2. Item 1A

Appeal of Planning Commission Resolution No. 26-05 Regarding Coastal Development Permit No. 19-012 (25200 Pacific Coast Highway, APNs 4459-013-021 and 4459-014-018; Owner, PAR PCH, LLC; Appellant, Jun Hall for Concerned Citizens of Malibu Road, Inc.)

Amended[1] Malibu City Council
Special Meeting Agenda

Proposed Outdoor Kitchen

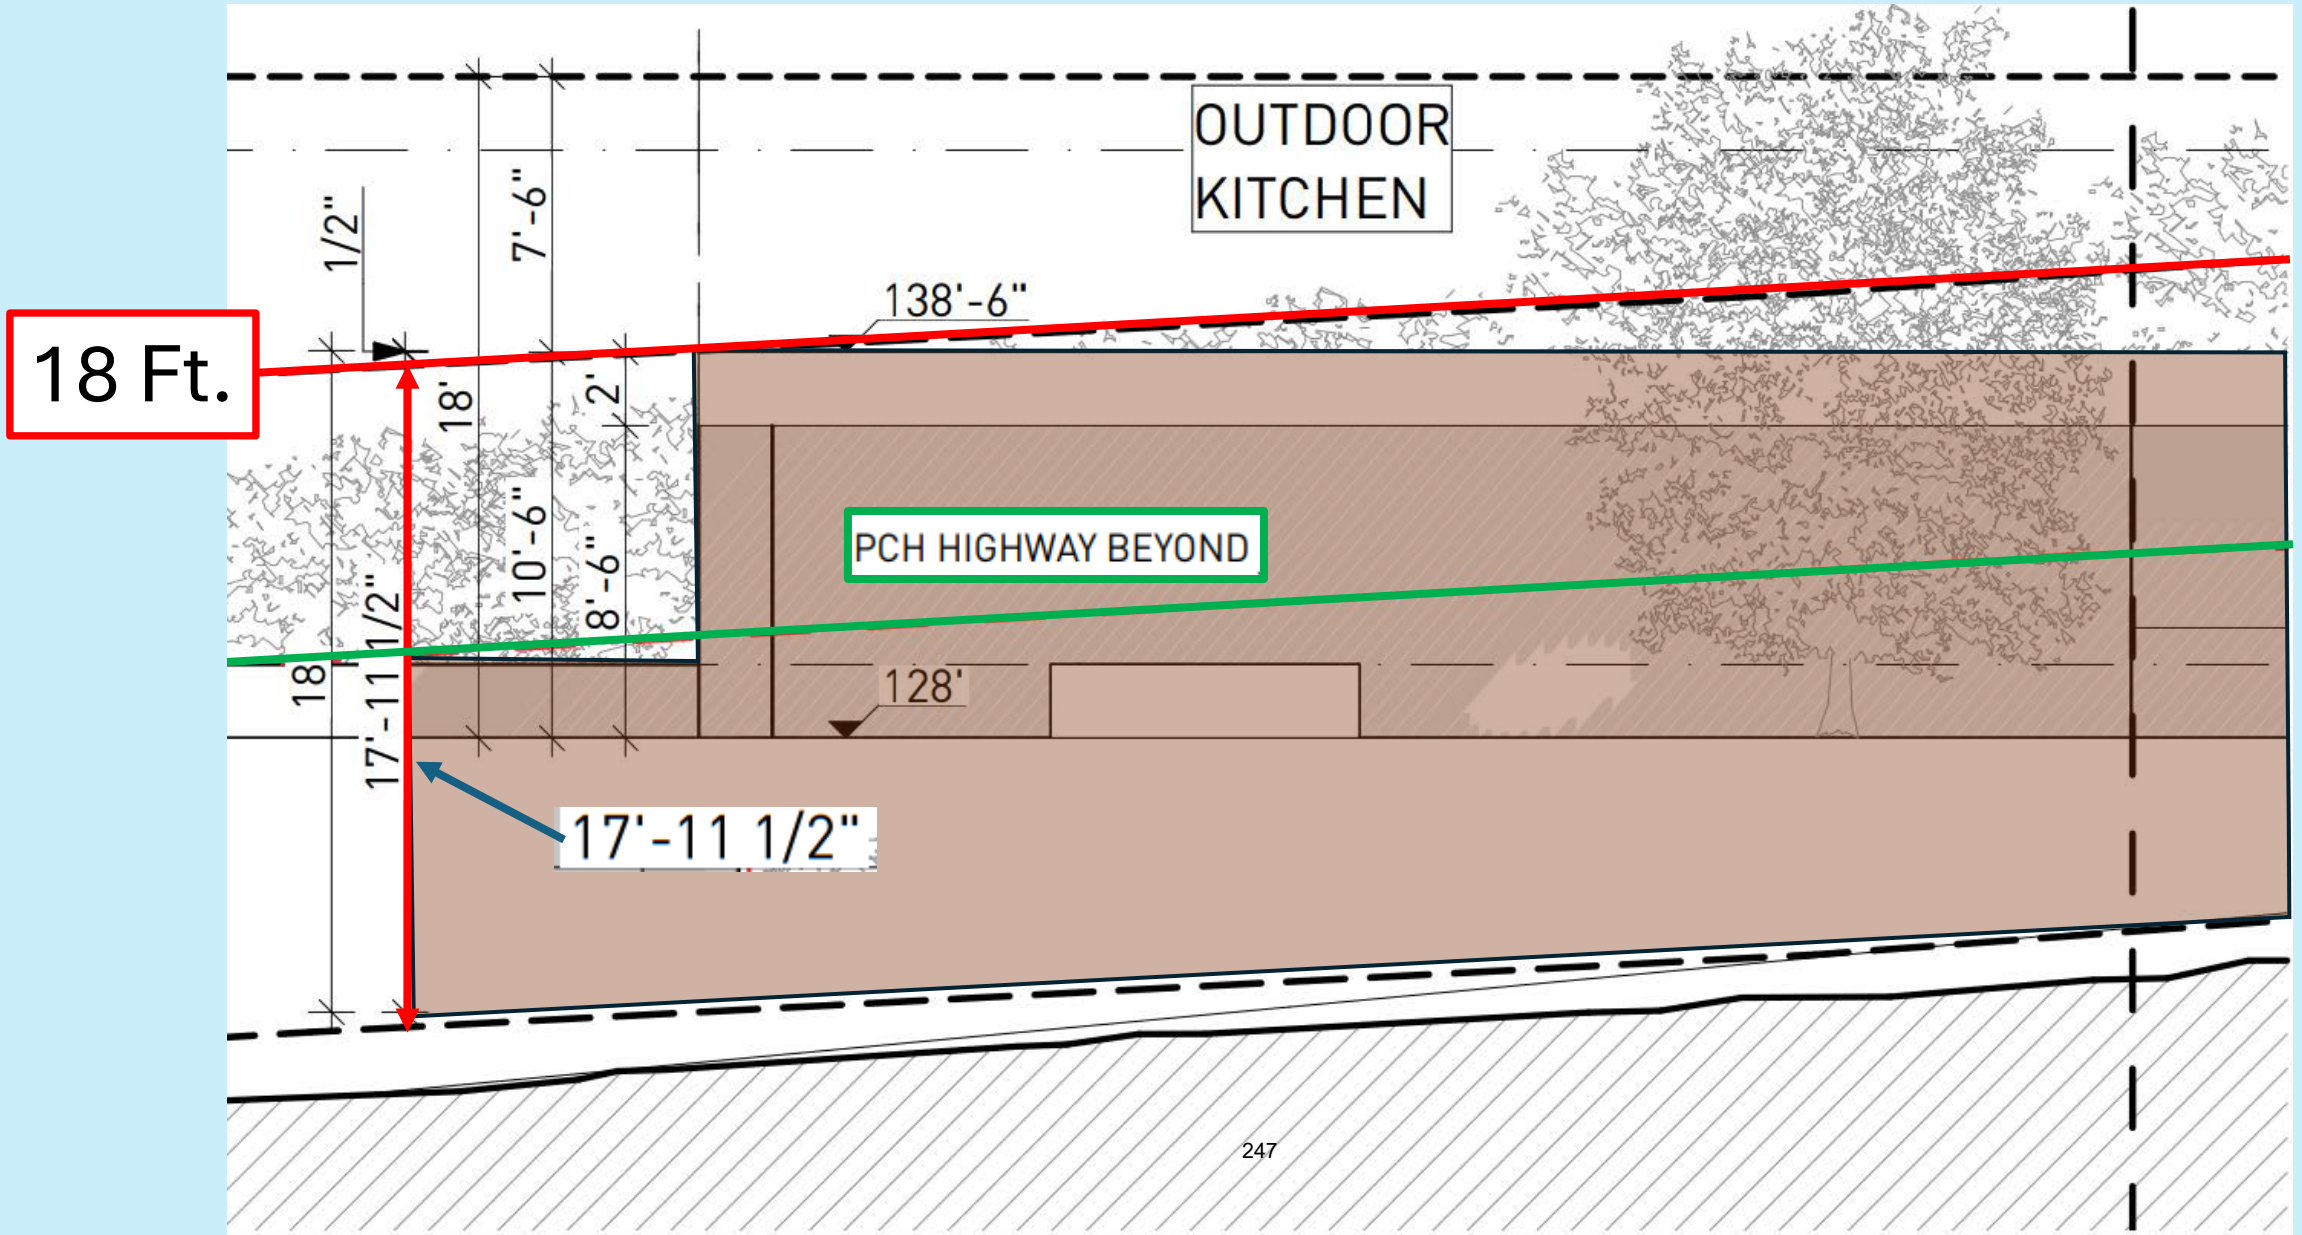
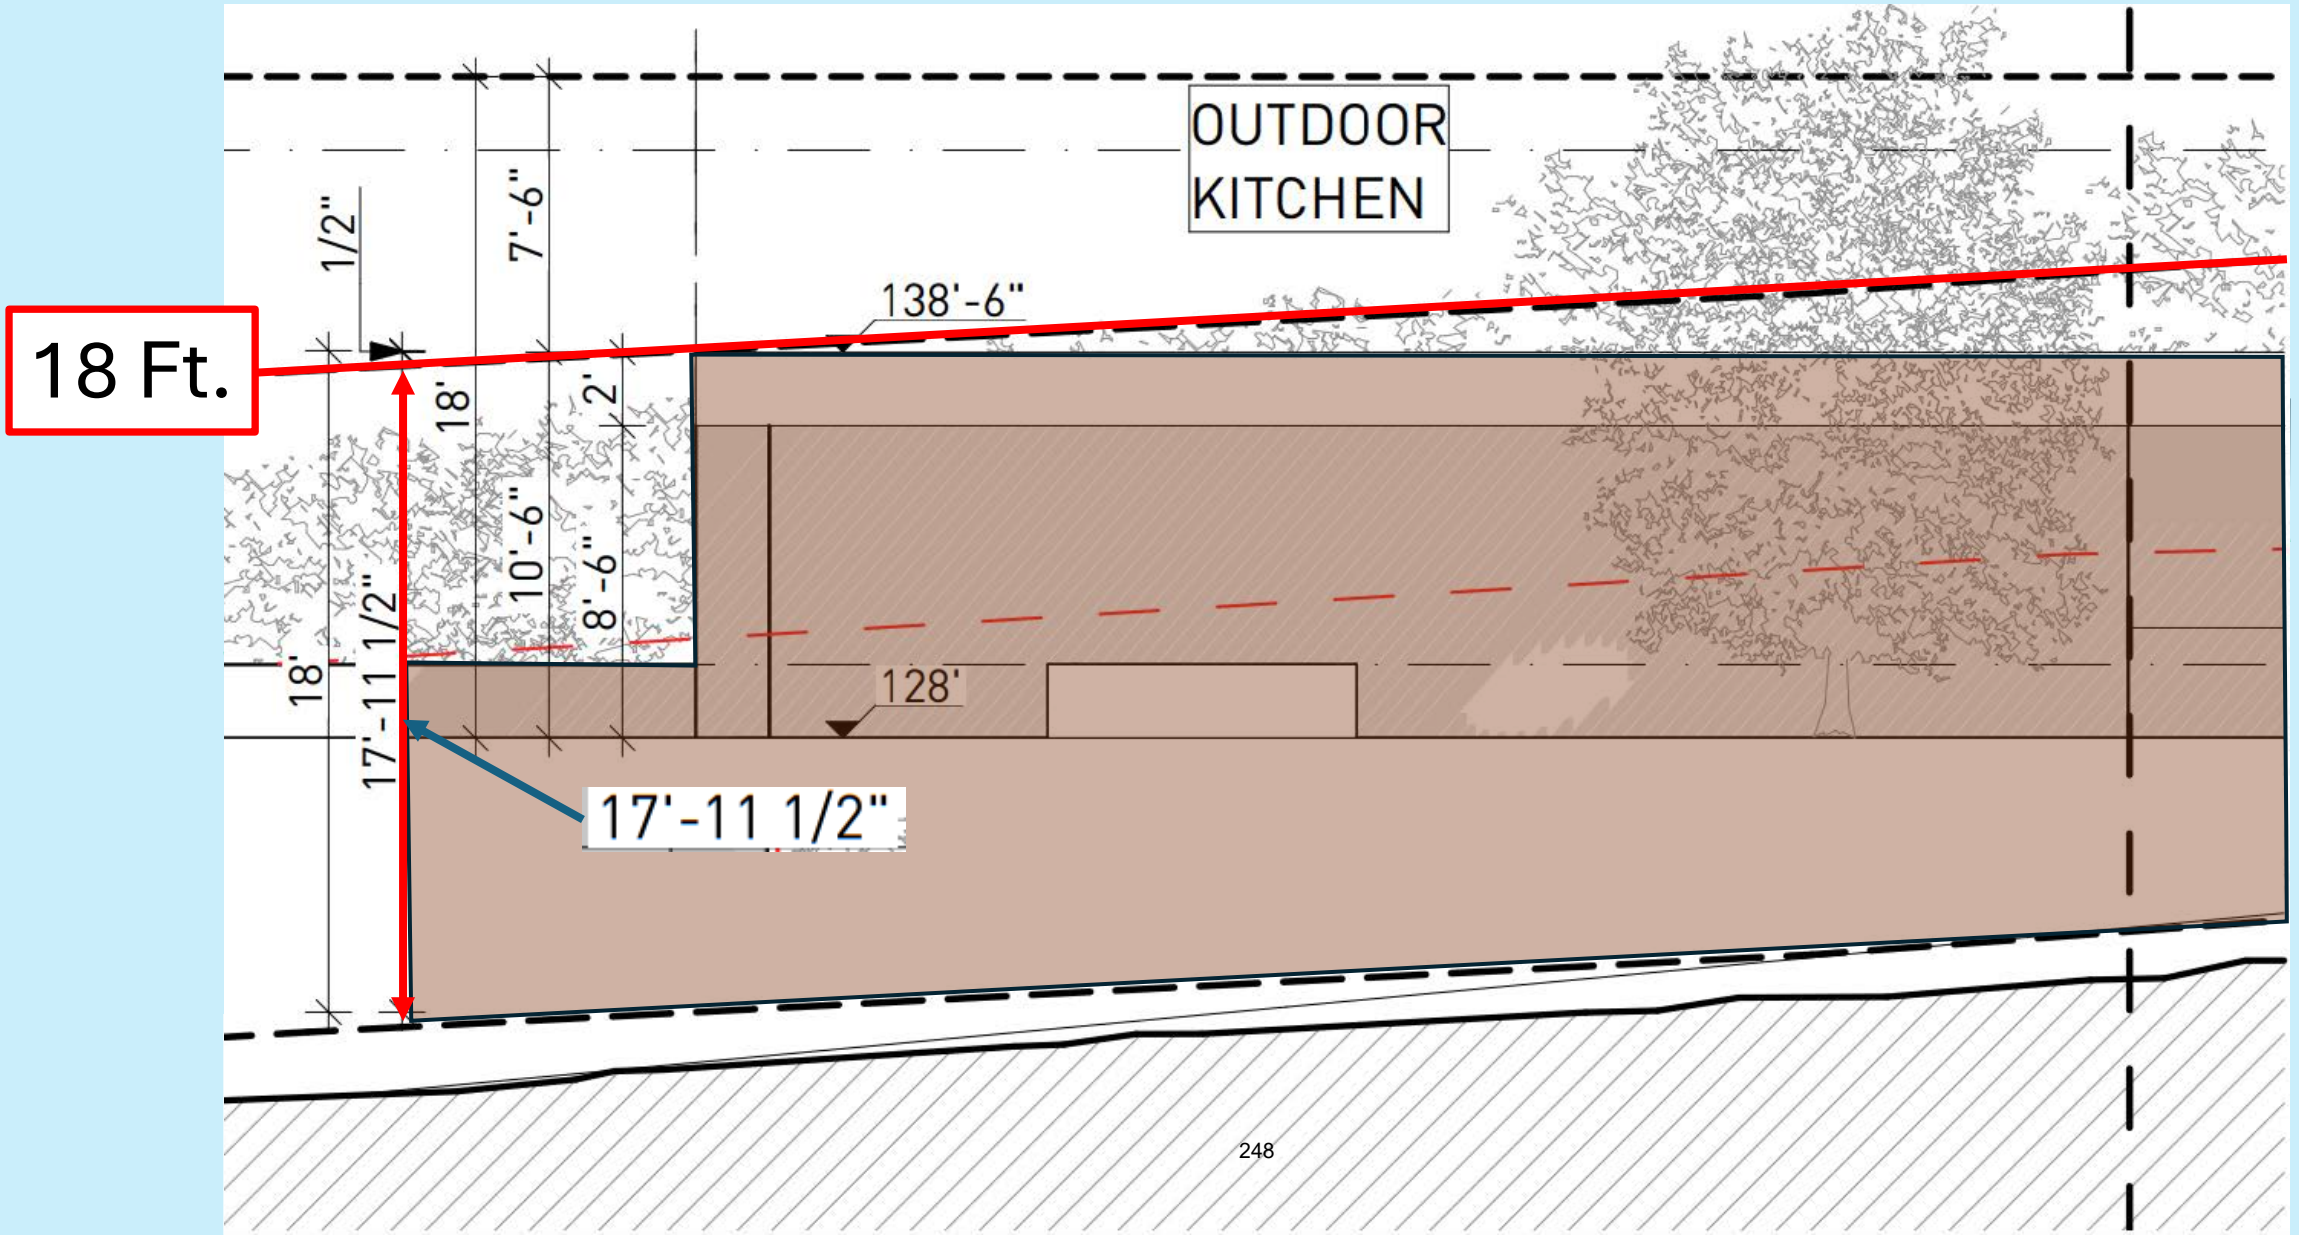
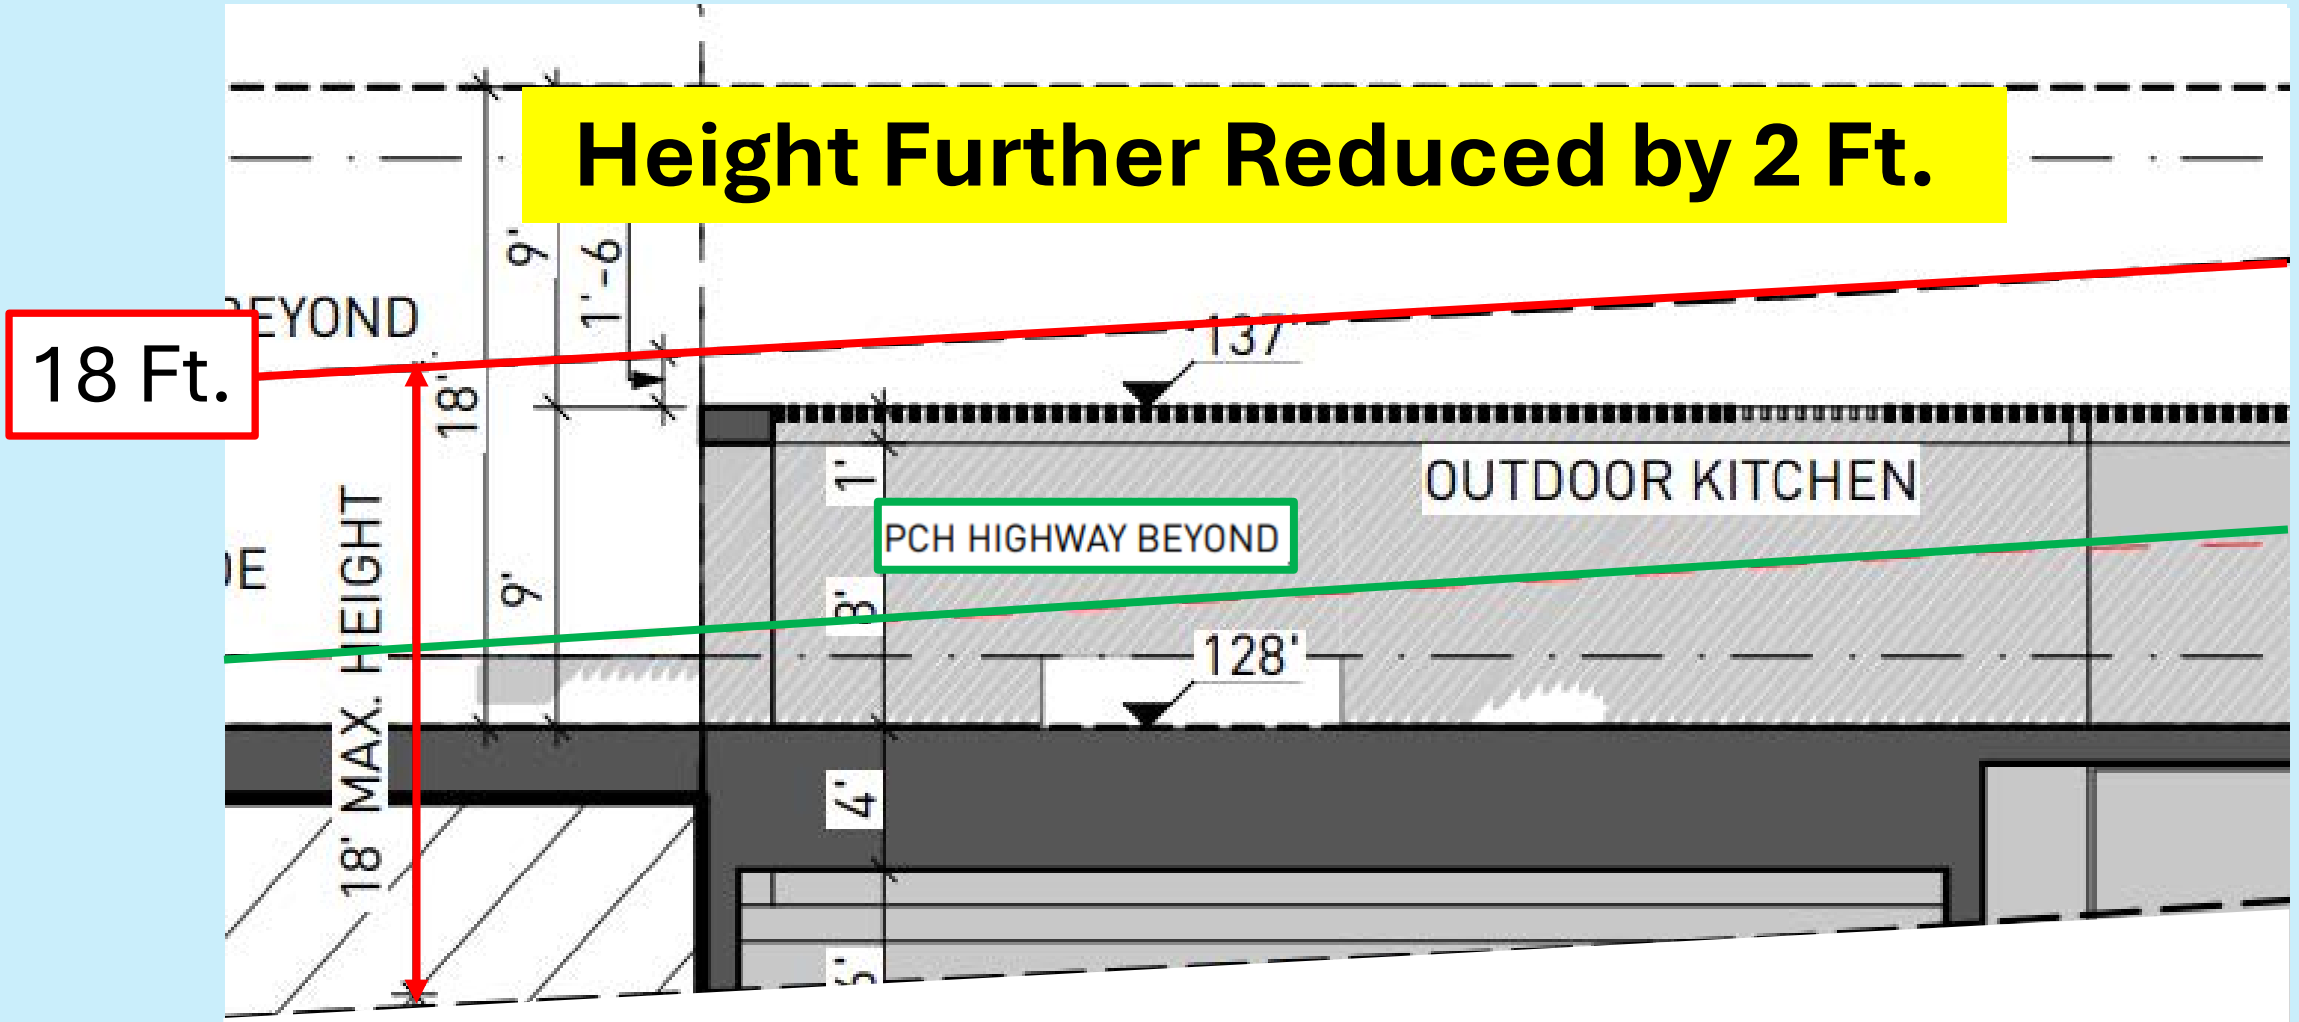
Outdoor Kitchen Originally 17ft., 11 in. Tall

Outdoor Kitchen Reduced to 16ft., 5.5 in. Tall

Outdoor Kitchen Reduced to 14ft., 6 in. Tall

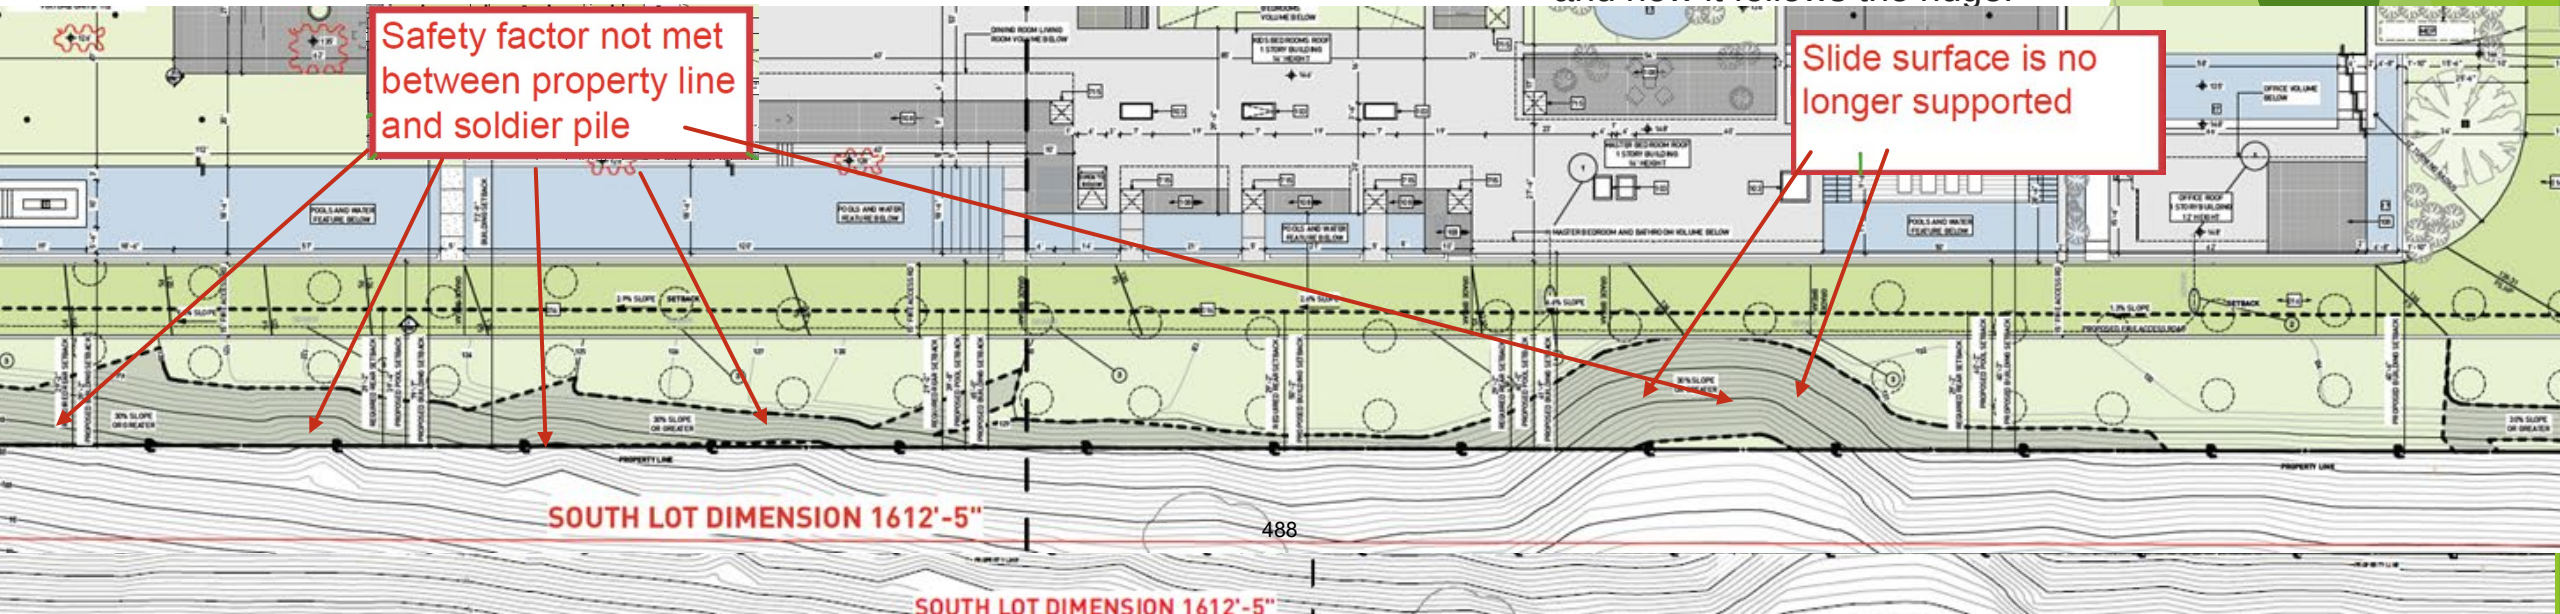
This is where the safety factor is clearly not met – They **moved/relocated** the soldier piles a few feet to avoid a slope variance and now they need a variance because there is space between the property line and the soldier piles where the safety factor is not met.

In addition, they are no longer supporting the slide in front of the MASTER area, and this would cause a slide into adjacent properties. This first image is before they moved the piles and shows the property line, it used to follow a straight line and now it follows the ridge.
